Rev A list of changes

PROJECT
200 THE BROADWAY, YMCA
LONDON, SW19 1RY

TITLE
Roof Plan

Proposed Roof Plan

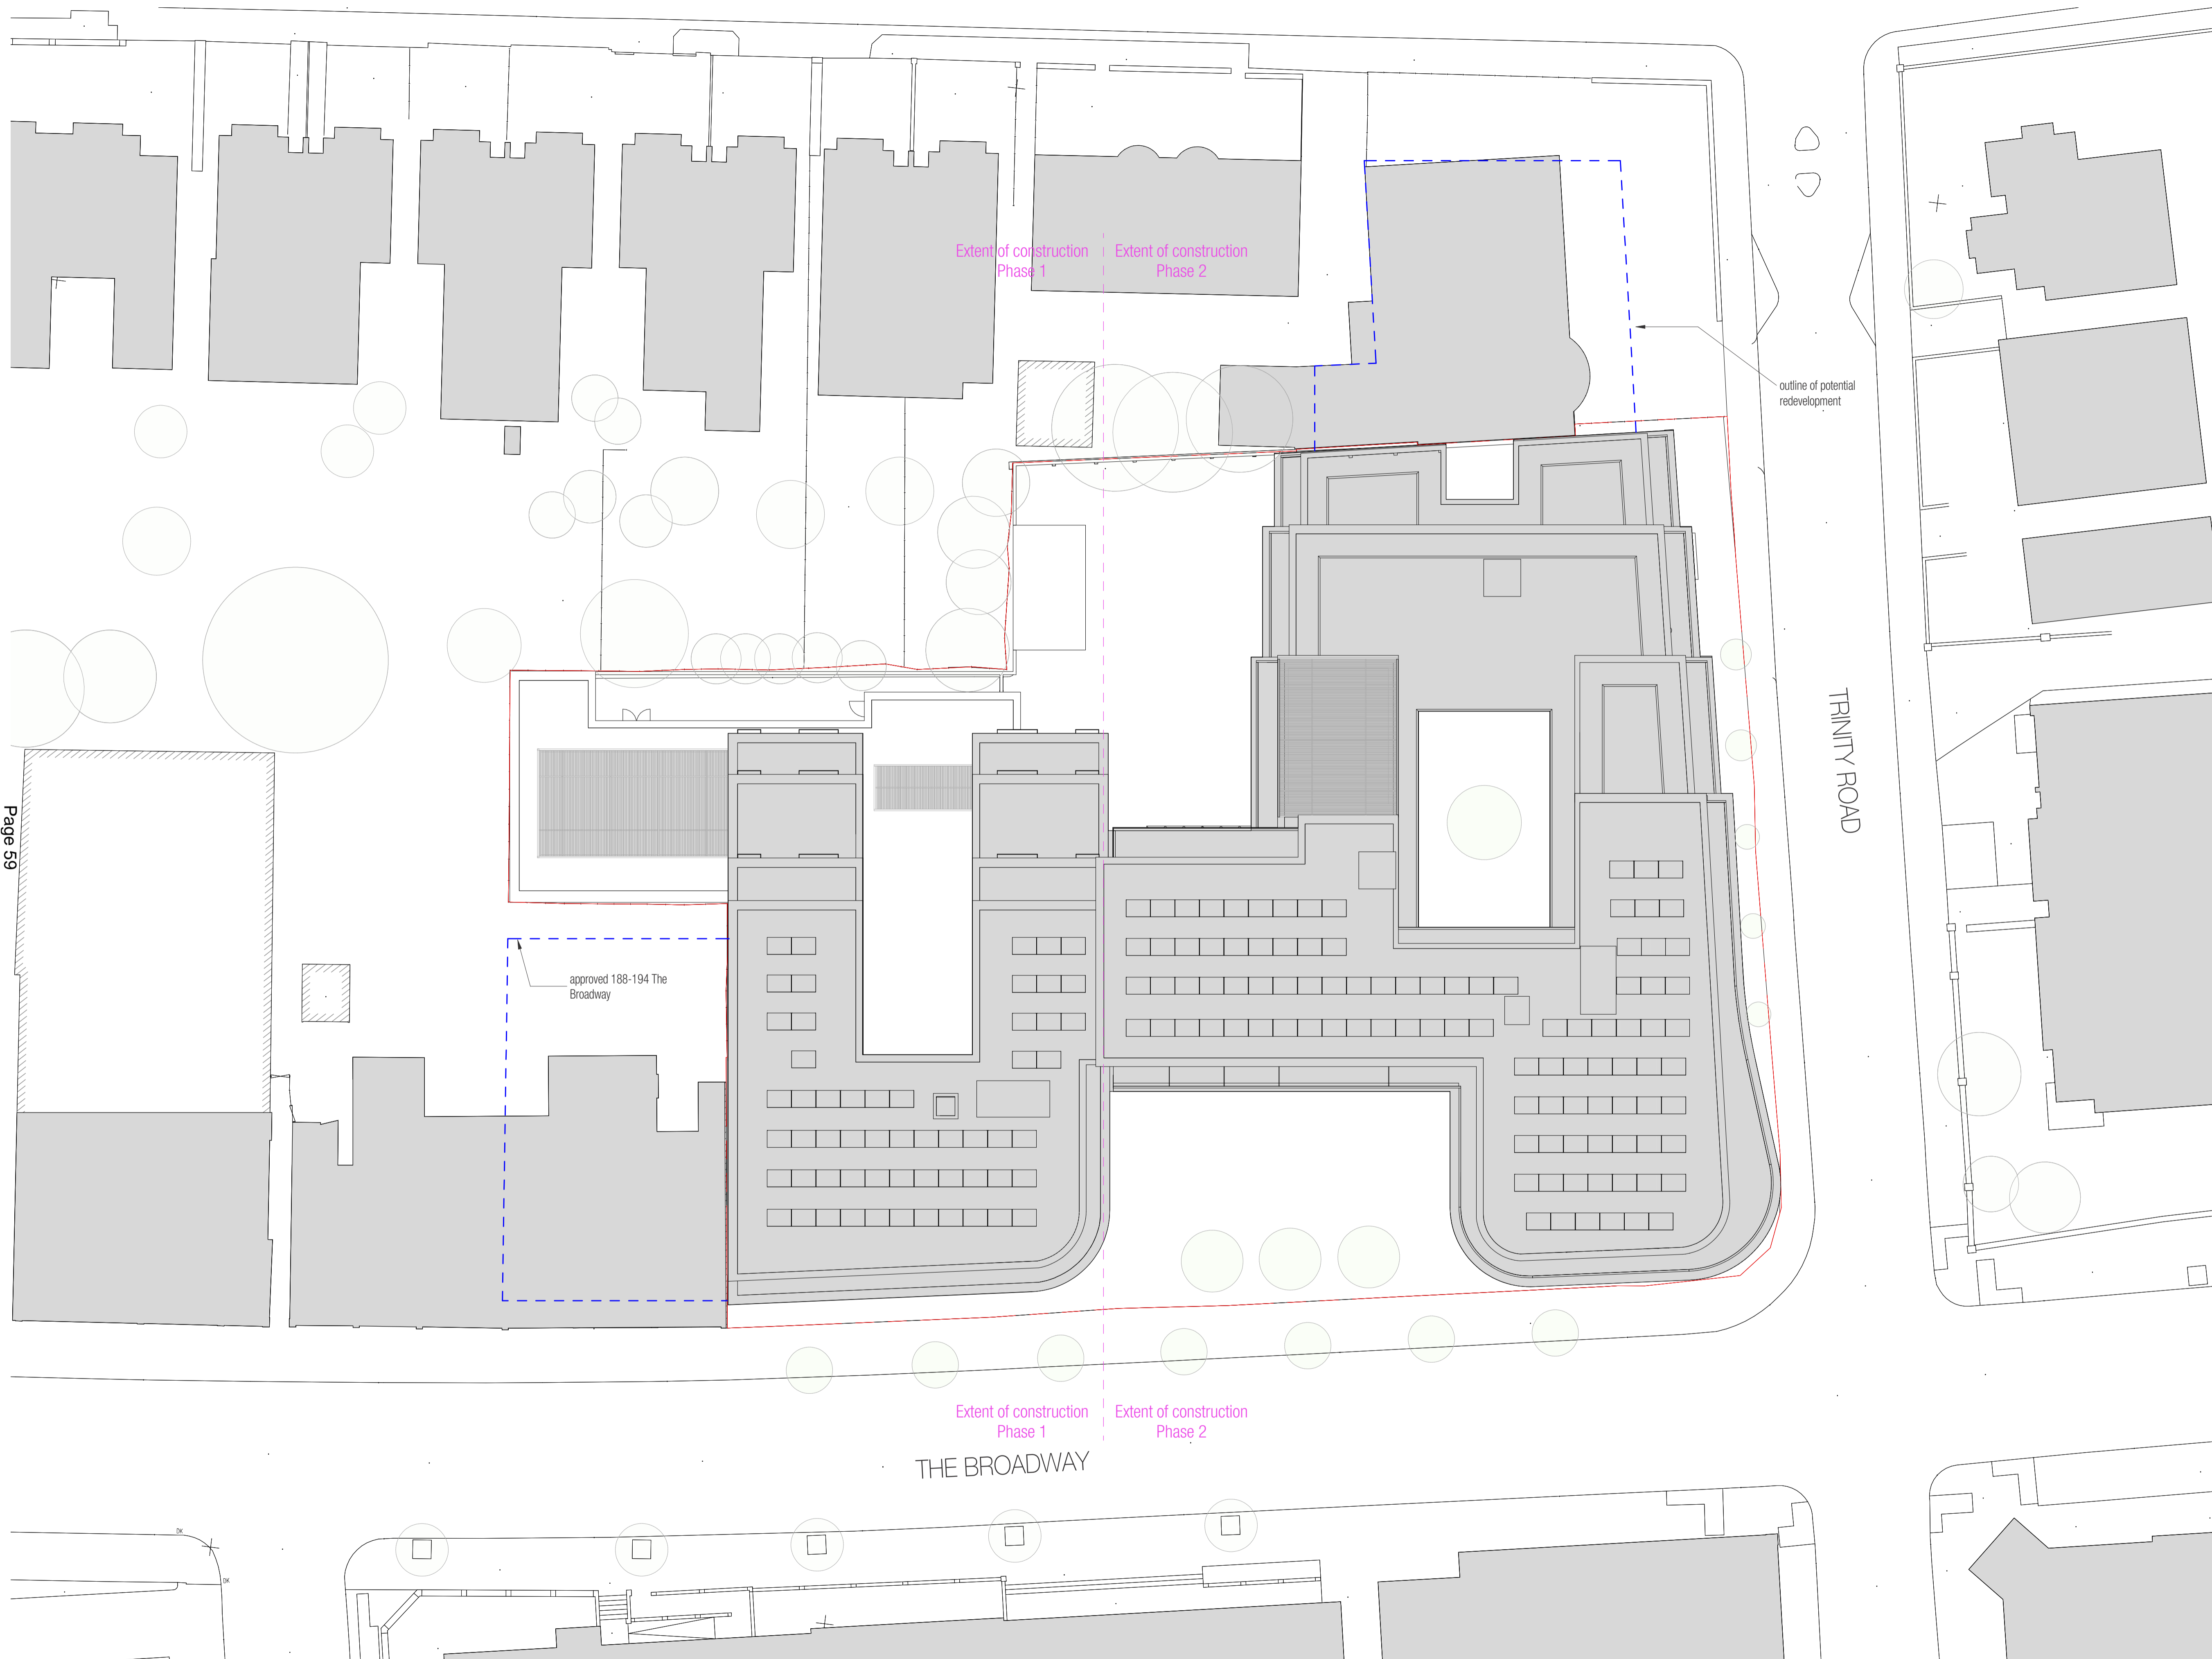
- Reduction in bedroom size in the 1b1p units.
- Addition of 750mm zone around beds in 1b2p central block units.
- Boundary treatment to ground floor duplexes on Trinity Road reduced from 1.5m height to 1.2m.
- Ground floor duplex gardens/bins store reconfiguration.
- Additional side door from servicing corridor to central commercial unit.
- Amendments to the enlarged cycle parking spaces to provide a secured and lockable store.
- Short stay cycle parking relocated from Trinity Road to central piazza.
- Provision of clear link from service yard to residential concierge lobby.
- Windows in YMCA amended to show perforated panels to avoid overlooking.
- Screen aligned with vertical mullions in central block façade facing The Broadway.
